Petition Number: #2022-086 General Location Identifier: 02962101

Date	Description		
11-28-22	First Review (TM)

General Review Information

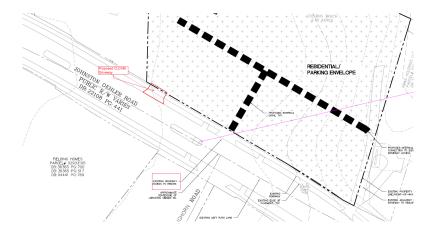
- 1. **Curbline:** The proposed zoning district has a setback measured from back of the existing or proposed future curbline.
 - a. **Johnston Oehler Road:** The future location of curb and gutter is in its existing location.

Label and dimension the curb and gutter from the centerline for each road on the site plan.
